**From:** [Luana Casale](#)  
**To:** [Zachary De Meneghi](#)  
**Cc:** [Melanie Tan](#)  
**Subject:** Fwd: LOT 5-42, PH5, REVISED FINLAY FLOOR PLAN - LAUNDRY ROOM  
**Date:** Sunday, April 16, 2023 11:36:34 AM  
**Attachments:** [image005.png](#)  
[image006.png](#)  
[image007.png](#)  
[image008.png](#)  
[image005.png](#)  
[image006.png](#)  
[image007.png](#)  
[image008.png](#)

**From:** Iqbal Shahid <shahidim@rogers.com>  
**Date:** April 15, 2023 at 10:46:58 PM EDT  
**To:** Luana Casale <luana@lormelhomes.com>  
**Subject:** Re: LOT 5-42, PH5, REVISED FINLAY FLOOR PLAN - LAUNDRY ROOM

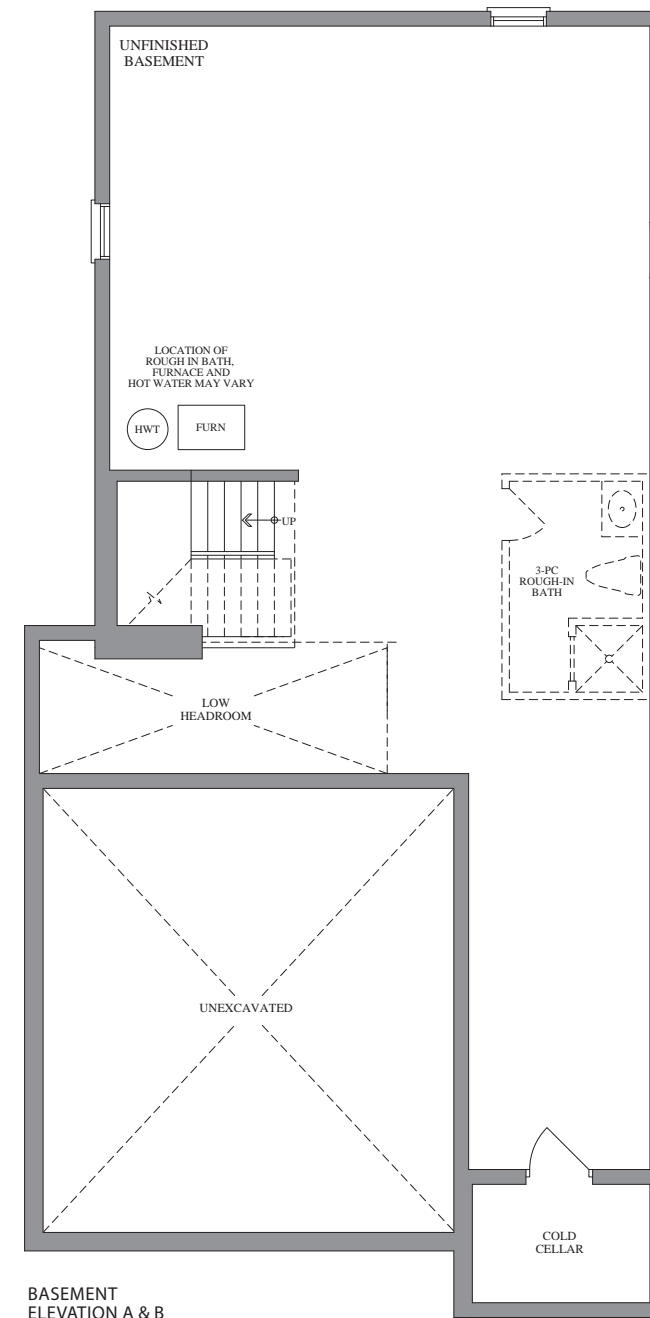
The plan has the door from the house to garage situated directly in front of the dryer. It seems however the spacing between the two may feel tight, especially when opening the dryer door and in the event the garage door opens.

Our construction team has suggested shifting the door to the garage as suggested the attached drawing. It's a good change and allows more space for dryer's door swing.

Lot 5-42 also agrees to move the door

I accept your suggested change door location. shifting the door to the garage as suggested the attached drawing.
